Project:
WATERSHED COTTAGES
KIRKLAND, WA

Subject: Watershed Cottages, Zon21-00113

This memorandum provides the staff responses to the transportation concerns raised in the public comments to the Watershed Cottages development.

A2

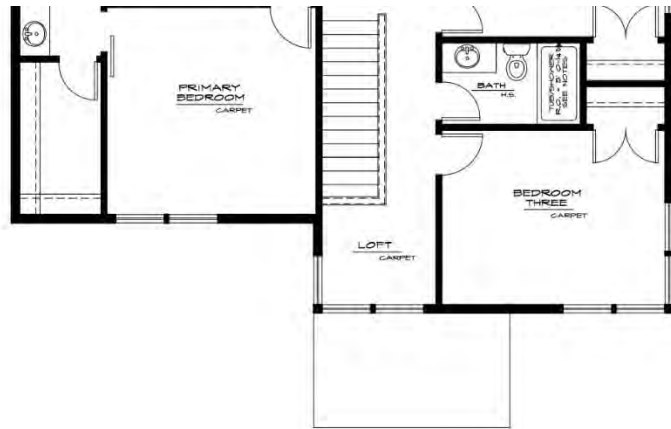
- 1) Proposed Cottage FAR of (13,888 sf) of exceeds max allowable Cottage FAR (13,125 sf) of the site
- 2) Proposed unit size of 1736 sf exceeds 1500 sf max "Gross Floor Area" per unit as defined

- 11) The siteplan details trees on our property that will be cut down in order to develop the site. We do not consent to the removal of any trees on our property or partially located on our property.
